NINE MILE POINT NUCLEAR STATION, UNIT NO. 1

AMENDMENT TO FACILITY OPERATING LICENSE

Amendment No. 65  
License No. DPR-63

SAFETY EVALUATION BY THE OFFICE OF NUCLEAR REACTOR REGULATION  
SUPPORTING AMENDMENT NO. 65 TO FACILITY OPERATING LICENSE NO. DPR-63

FIGURE K-2.7  
NINE MILE POINT NUCLEAR SITE  
INVESTIGATION ORGANIZATION

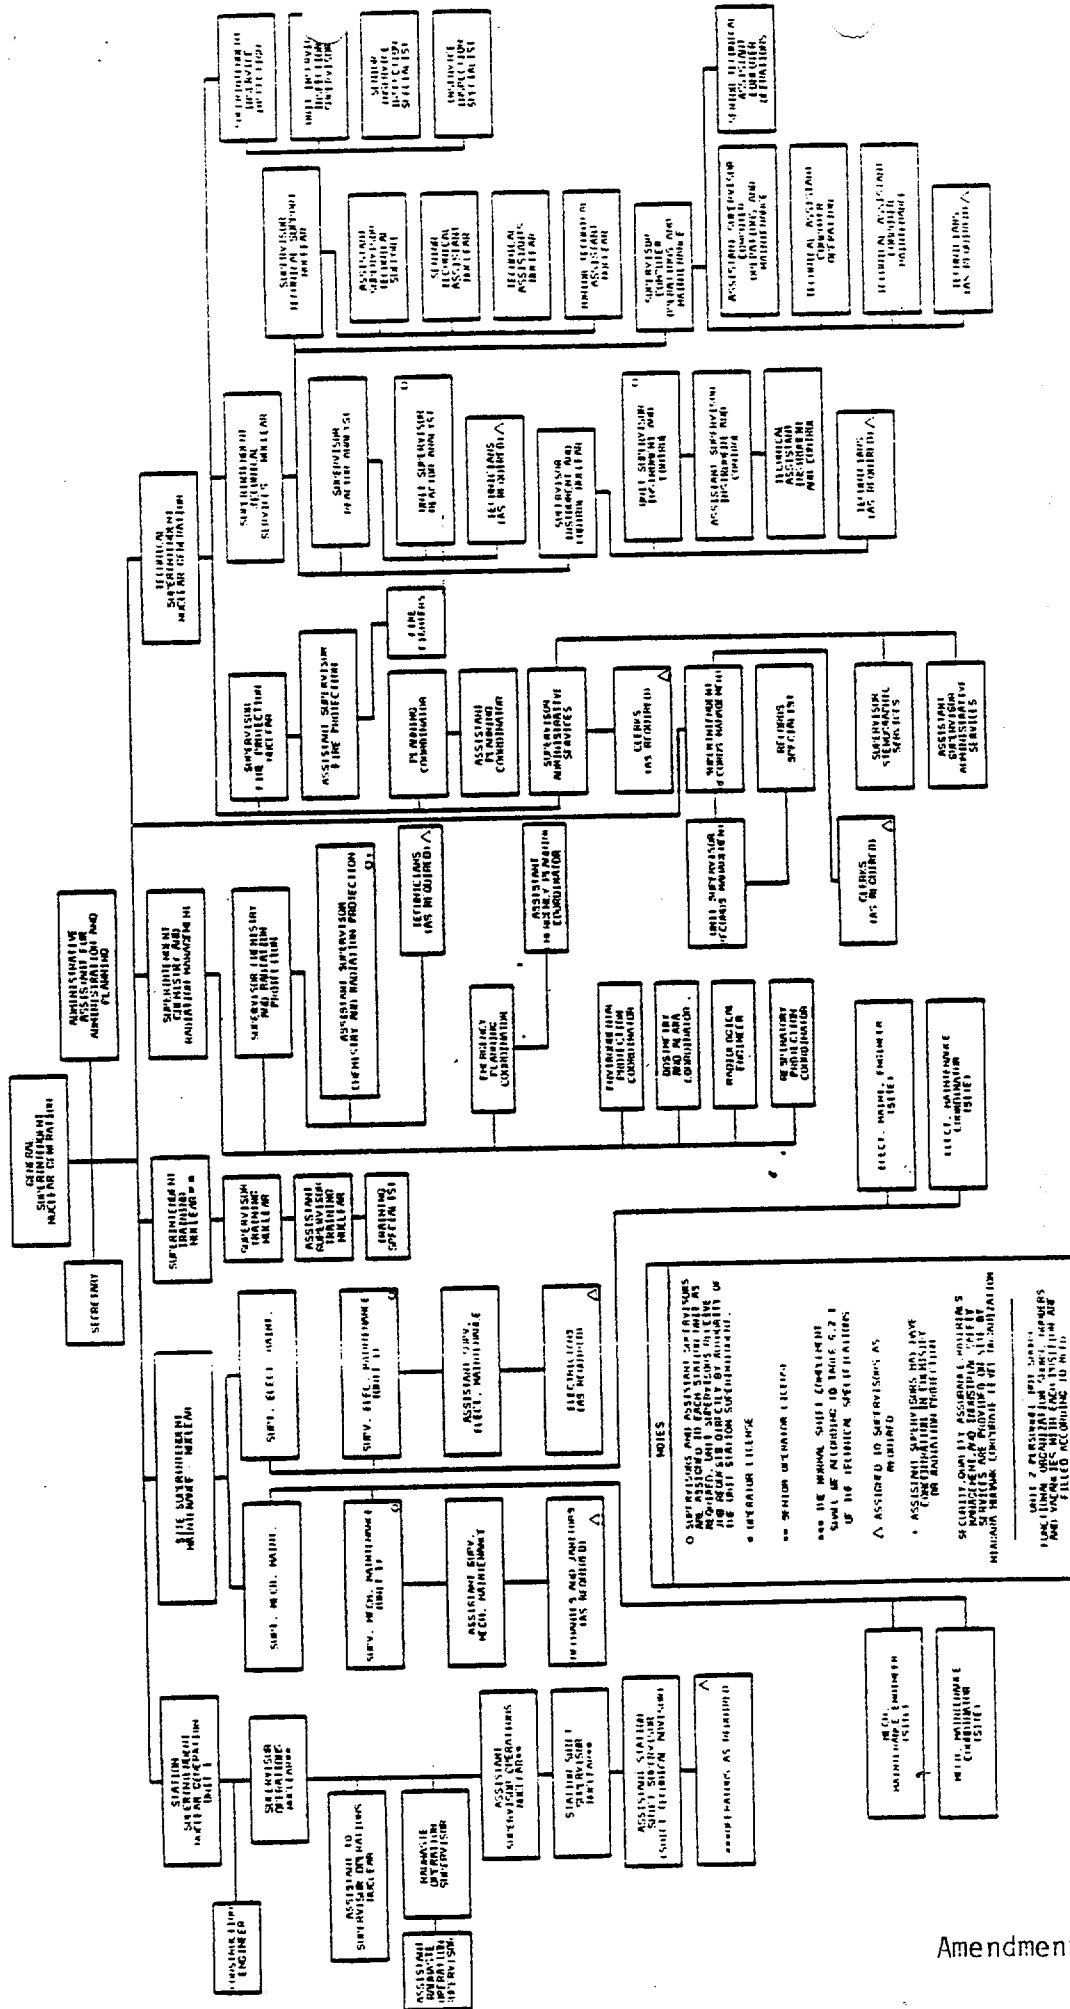
- Figure 6.2.2        The proposed changes to the plant organization effect primarily an increase in the number of plant staff positions. These are acceptable. However, the positions of Supervisor Mechanical Maintenance and Supervisor Electrical Maintenance have been deleted. In the old organization, these positions represented

the additional supervision available for outages. This additional supervision is still shown by the footnote to the Table. The change is strictly administrative and, therefore, acceptable.
